Access Compliance Report

Public Rights-of-Way

(Curb Ramps)

Intersection ID: 30006	Main Street: FULLERTON_CT	Cross Street: OAKBORO_LN	Location: SW
ADA ID: D5234B74B635	Ramp Type: BlendTrans2	Initial Pass/Fail: Fail	Overall Compliance: No
Codes/Mitigation Info/Possible Solution		Field Measurements/Component Compliance	
Severity Score: 8.75

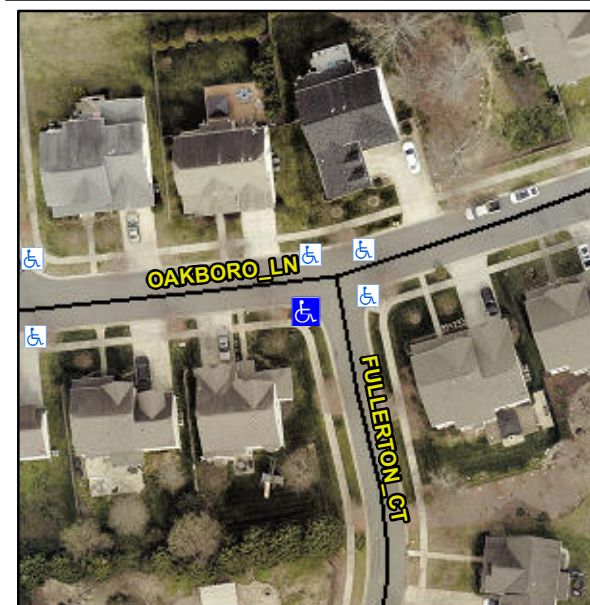
Remove & Replace Curb Ramp With Two New Directional Ramps or Equivalent.

Not Found, R304.5.1
